Product Change Notification

MultiConnect[®] rCell 100 Series Cellular Routers

LTE Category 4 Models Only

PCN 12072020-02

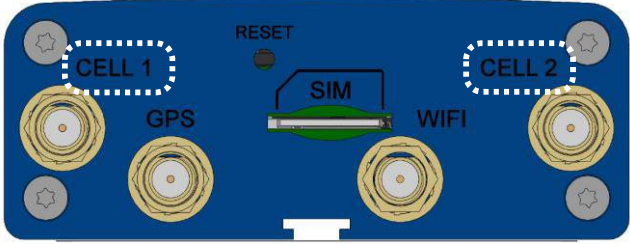
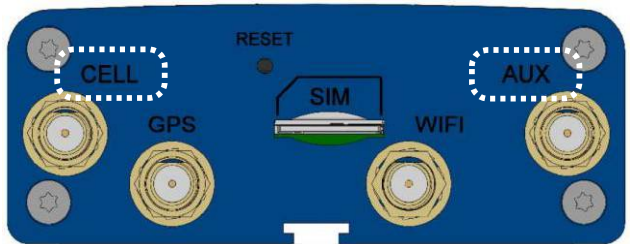
Below are images that show these changes. Note: -B10 models include GPS and WIFI connectors. -B07 models do not include GPS and WIFI antenna connectors.

<p><u>New Side Panel</u></p> <p>WIFI antenna connector is moved 0.050 inches closer to the left edge of the panel</p> <p>RESET button opening is enlarged by 0.025 inches</p> <p>SIM card opening is 0.595 inches wide</p>
	<p><u>Old Side Panel</u></p> <p>WIFI antenna connector for is located 1.950 inches from the left edge of the panel</p> <p>RESET button opening is 0.075 inches</p> <p>SIM card opening is 0.535 inches wide</p>

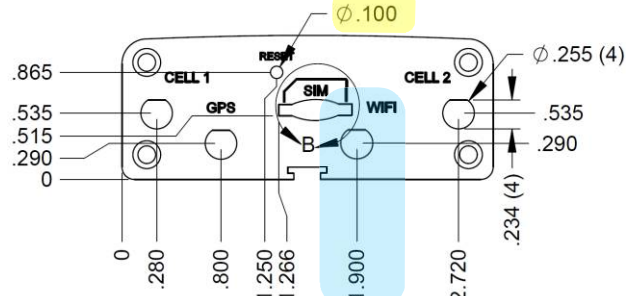
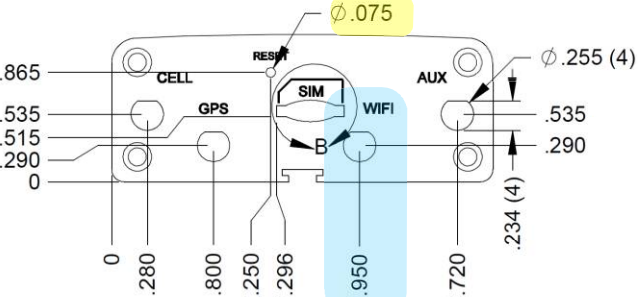
The LTE antenna connectors are renamed “CELL 1” and “CELL 2.” Below are images that demonstrate these differences. Note: LTE Category 4 cellular require two cellular antennas.

<p><u>New Side Panel</u></p> <p>CELL 1 and CELL 2 labels for LTE antenna connectors</p> <p>Note: -B10 models shown. -B07 models do not include GPS and WIFI antenna connectors</p>
	<p><u>Old Side Panel</u></p> <p>CELL and AUX labels for LTE antenna connectors</p> <p>Note: -B10 models shown. -B07 models do not include GPS and WIFI antenna connectors</p>
